City of Ketchum

Recommendation to Approve Encroachment Agreement 20460 with Miles Stanislav for 105 Georgina Road

WARM SPRINGS CREEK BANK REPAIR PROJECT STANISLAW PROPERTY, CITY OF KETCHUM, IDAHO DESIGN PLANS

IN RE:)
)
Stanislaw Stream Alteration/Bank Stabilization) KETCHUM PLANNING AND BUILDING DEPARTMENT
Floodplain Development and Waterways) FINDINGS OF FACT, CONCLUSIONS OF LAW, AND
Design Review Permit) DECISION
Date: P19-070)
)
File Number: P19-070)

**PROPOSED GRADING
PLAN & SECTIONS**

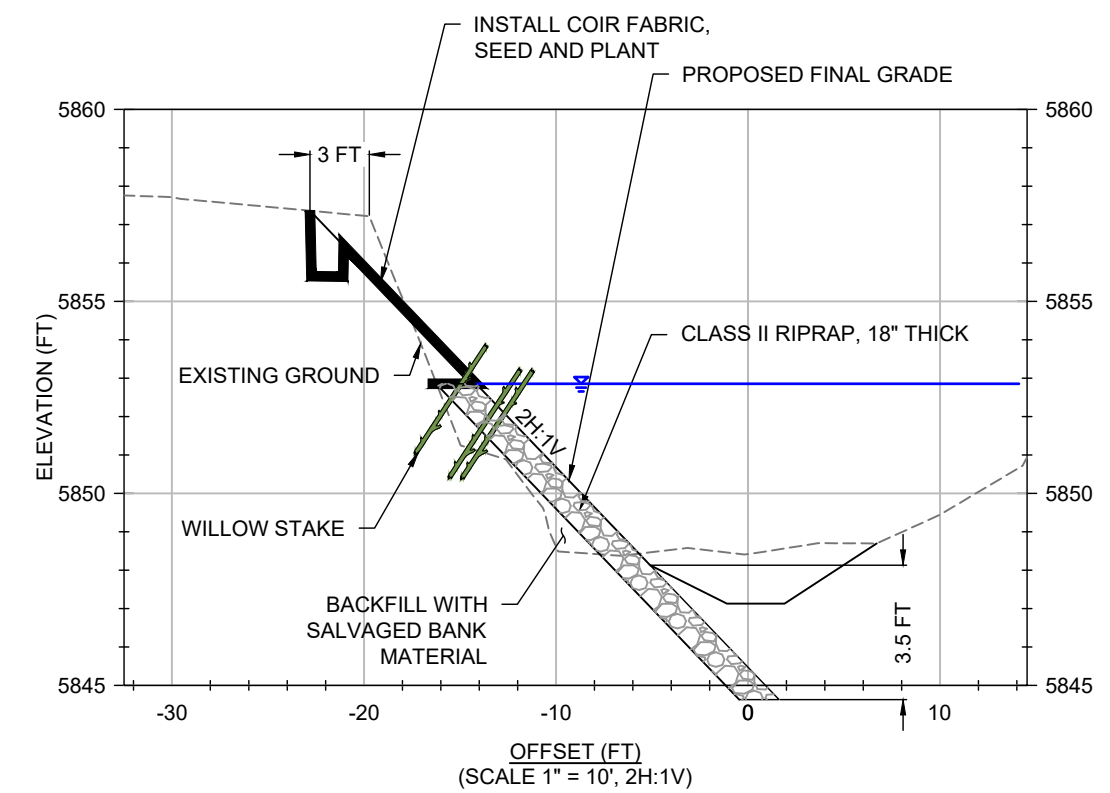
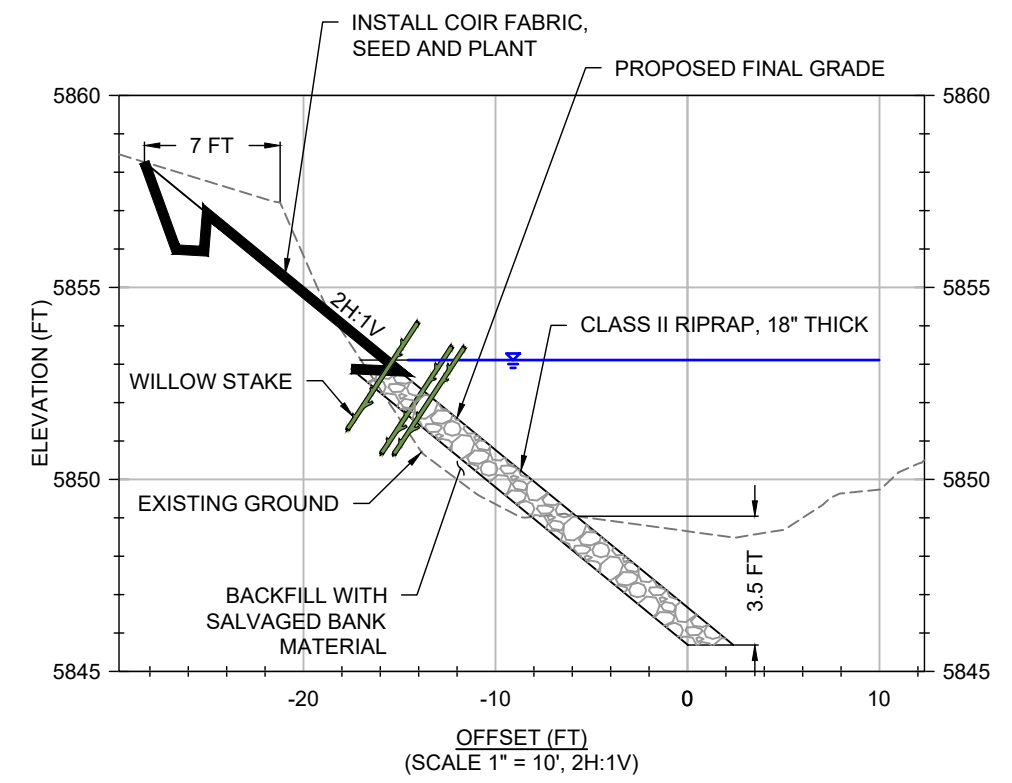
First, the applicant's contractor appears to have flagrantly violated the City's Stream Alteration Regulations by proceeding with removal of the two large trees BEFORE the applicant has received the City's permission. If this is true, this would be a serious violation of the City's rules and the City should impose significant consequences. We suggest the City consider approaching this as comparable to a construction code violation by the contractor and by the homeowner. If the City ignores the preemptive behavior, proponents of future stream projects will have little incentive to seek the City's consent.

Whether or not the City ultimately approves the removal of the two trees, the contractor's preemptive actions preclude the City considering alternatives to their removal. In this case, the removal of the trees has decreased natural stream bank stabilization and reduced the availability of shade to mitigate stream temperature increases.

Second, this project will continue the past bad practices along this stretch of Warm Springs Creek. This stretch of Warm Springs Creek is deeply incised and straightened. Past practices have straightened the stream, deprived it of flood plain access, and hardened the bank. These practices have increased flow

Figure 3 Cross Section 7575.2 at Project Site

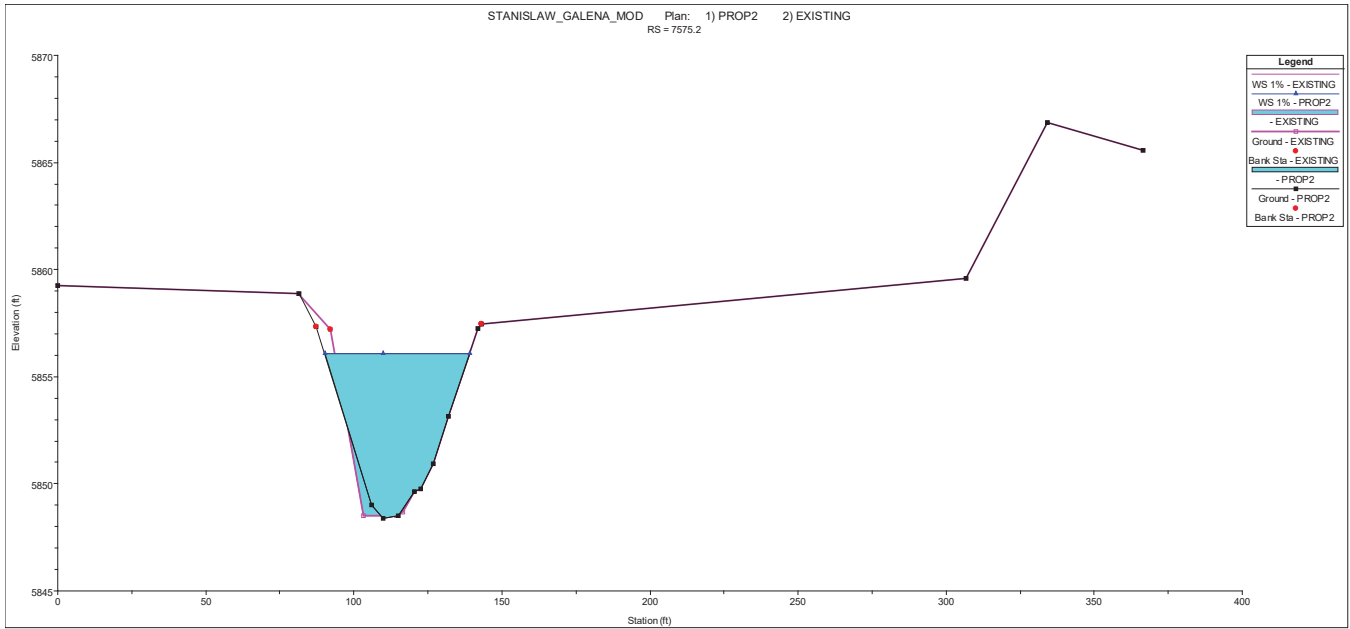
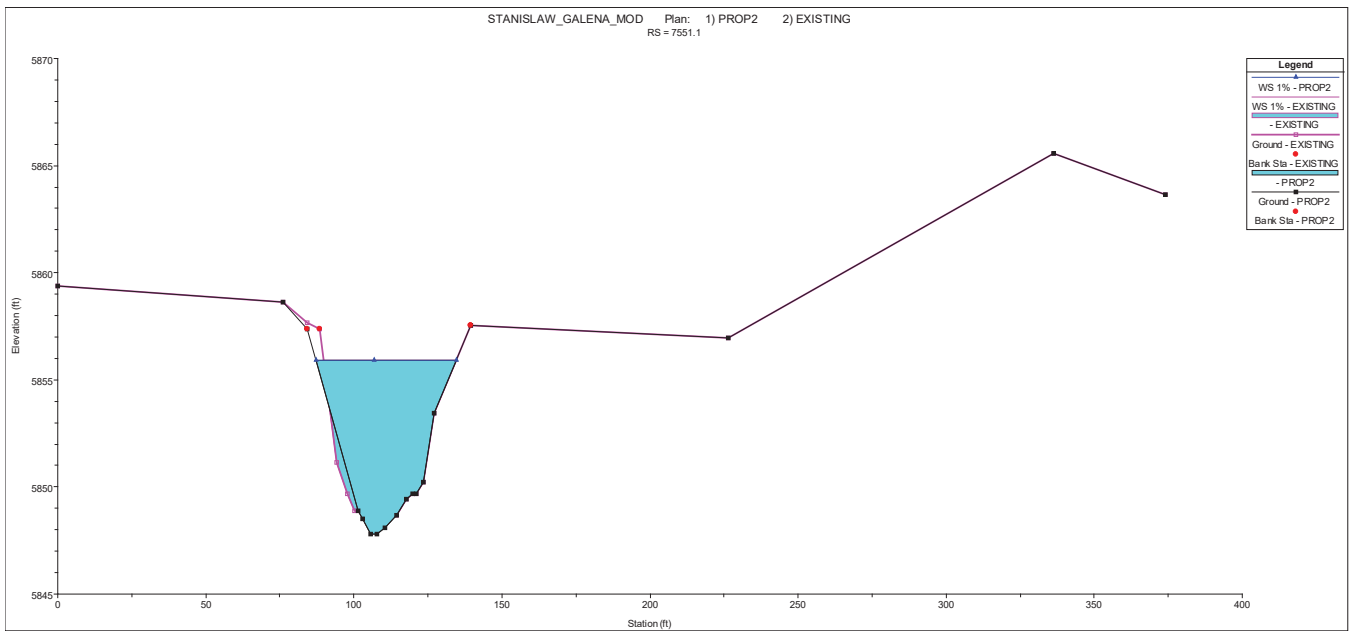
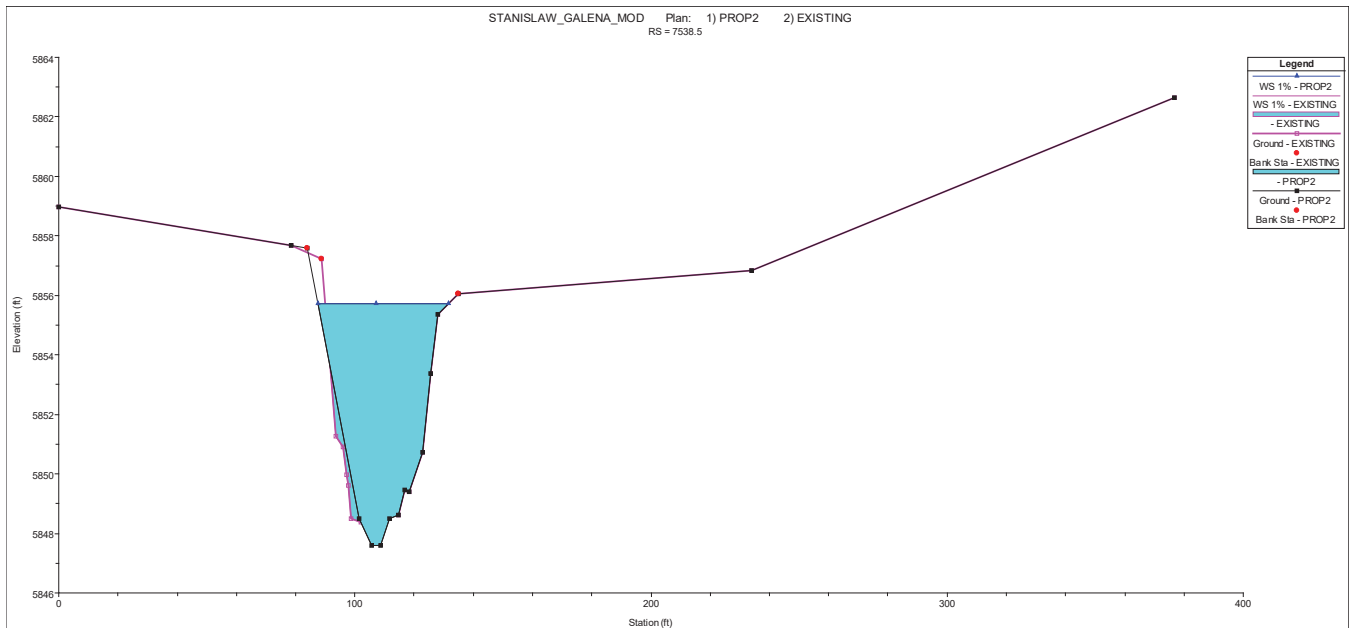
1. The existing condition model was revised and the values in Table 2 were inadvertently not updated to match the most recent model output. The report and model output has all been revised and is being attached to this report for review and concurrence. The proposed model at FEMA section M has a 0.00 difference so the model was not extended.

2. Biota revised the design plans to be in agreement with sections modeled in the proposed condition scenario. The revised plans are attached.
3. Two trees are at risk of being removed for the proposed grading. These trees are currently undercut and at risk of falling into Warm Springs Creek. Please see Figure 1 below shows the exposed roots and undercut bank along with loose bank material. Figure 2 shows the several trees that are hanging out over the bank and at risk of falling in the creek. These trees are a potential hazard to downstream properties and infrastructure. The proposed grading is to construct a stable 2H:1V slope that will be sustainable long-term solution. The bank will be planted with willow stakes and seeded with native riparian seed mix. The two trees at the top of the bank will be replaced with similar riparian species at the new top of bank location.

The resulting BFEs or 1% AEP (100-year) water surface elevations due to the proposed Project are equal to the BFEs under existing conditions as shown in Table 2. In addition, the change in velocity is plus or minus a few hundredths of feet per second, resulting in no change to the erosive conditions. Thus, the conveyance analysis is supportive of the enclosed No-Rise Certification. The proposed stream alteration to alter and stabilize the bank for the parcel of interest shall have no adverse impact on the fish habitat or local public interest. "No adverse impact" means that the proposed Project will not have any deleterious
